1964 Corvette: Engineering Service Letter: Muncie Four Speed Transmission Design Change

ENGINEERING SERVICE LETTER

SUBJECT: MUNCIE FOUR SPEED TRANSMISSION - 1964 DESIGN
CHANGE AFFECTING PAST MODELS SERVICE REPLACEMENT
AND A FIELD FIX IF REQUIRED

DATE 8-20-63
SECTION 7
MODEL RPO M20 800-
1200-1600-1800 & RPO
M21-1200-1600-1800-1963

FIRST DESIGN

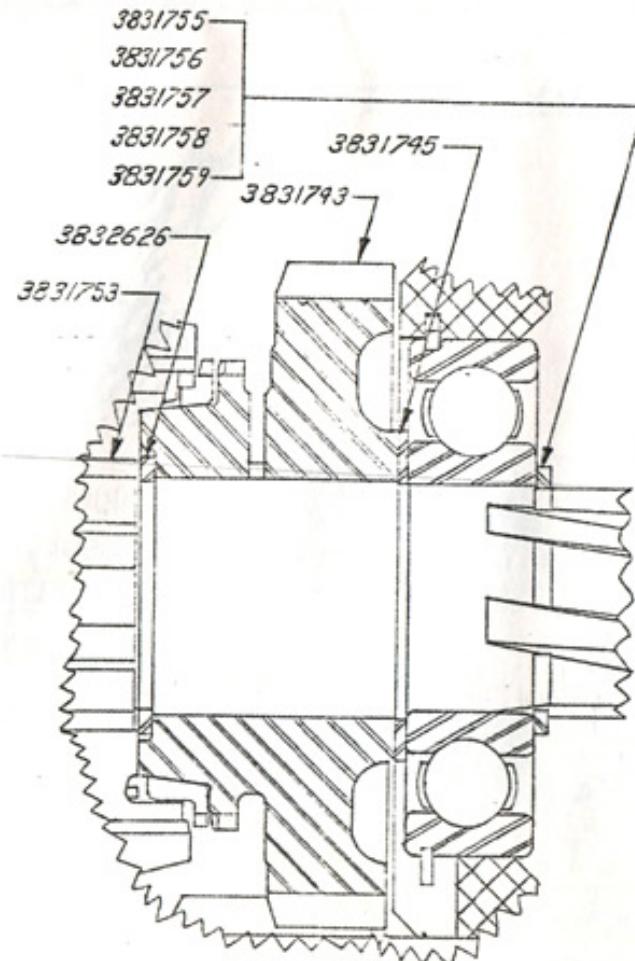
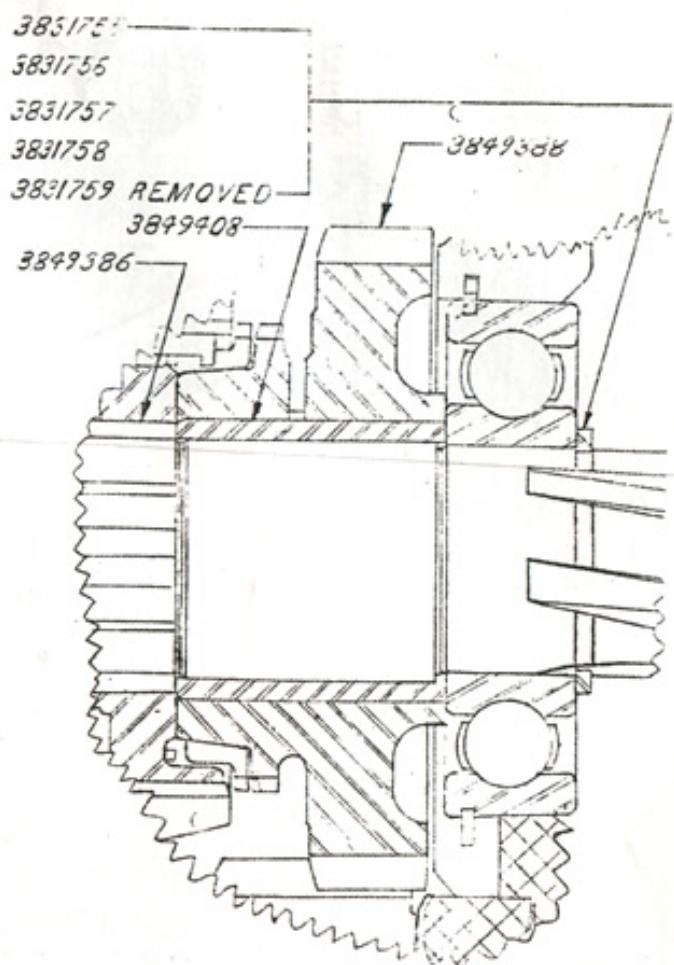
A design change is being introduced for start of production 1964 on subject transmission which includes a new transmission mainshaft, first speed gear, and first speed gear sleeve. The new parts are not interchangeable as details for service replacement on past models. The reasons for the changes are to provide positive first speed gear end clearance, and also to eliminate the possibility of seizure between the inside diameter of the first speed gear and the matching mainshaft outside diameter by use of a new sleeve. The seizure has been reported from the field in several instances at relatively low mileage, and the new parts indicated above are to be used for past model service replacement if this type of transmission failure is noted.

For a comparison between the new and old design in the transmission area affected see attached sketch. Old parts indicated by an asterisk (*) are no longer required as part of revised design.

From the viewpoint of excessive cost to the customer, if the combination of new parts was used for all past model service replacement, it was decided to maintain old stock.
